**SUNDRY NOTICES AND REPORTS ON WELLS**  
*Do not use this form for proposals to drill or to re-enter an abandoned well. Use form 3160-3 (APD) for such proposals.*

8. Well Name and No.  
TODD 23A FEDERAL 38

Devon Energy Production Company, LP respectfully request approval to abandon the MORrow and recomplete in the Atoka. **(SAND DUNES; ATOKA)**

**Todd 23A Federal 38**  
**30-015-35076**  
**Devon Energy Production Co., LP**  
**February 03, 2014**  
**Conditions of Approval**

Well Name: TODD 23A FED 38		Field: INGLE WELLS	
Location: 660' FNL & 860' FEL; SEC 23-T23S-R31E		County: EDDY	State: NM
Elevation: 3509' KB; 3486' GL		Spud Date: 11/10/06	Compl Date:
API#: 30-015-35076	Prepared by: Ronnie Slack	Date: 2/20/07	Rev:

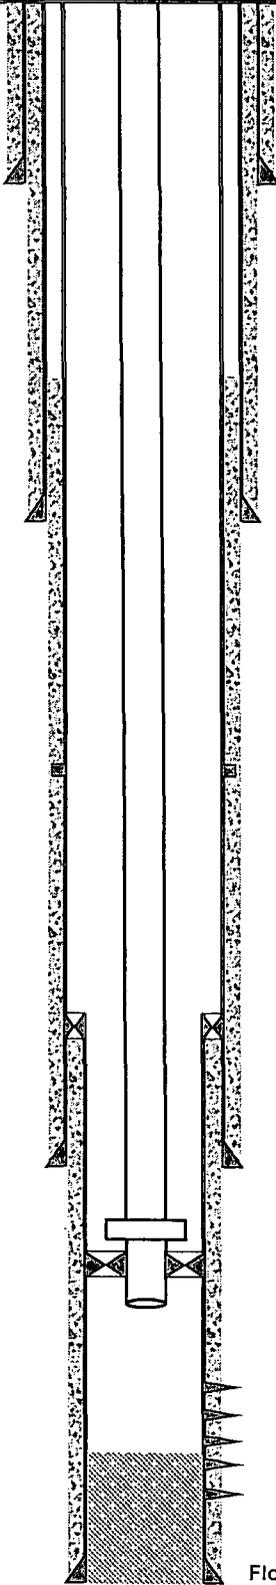
- 1. Operator shall place CIBP at 14,655' and place a minimum of 25 sx class H cement plug on top. Tag required.**
- 2. Operator shall place a balanced class H cement plug from 14,473'-14,223' to seal the top of the Morrow formation.**

**NOTE: Operator has the option of setting a solid plug on from the CIBP at 14,655'-14,223' instead of step 1 and 2.**

- 3. Must conduct a casing integrity test to maximum treating pressure before any work can be done. Submit results to BLM.**
4. Before casing or a liner is added or replaced, prior BLM approval of the design is required. Use notice of intent Form 3160-5.
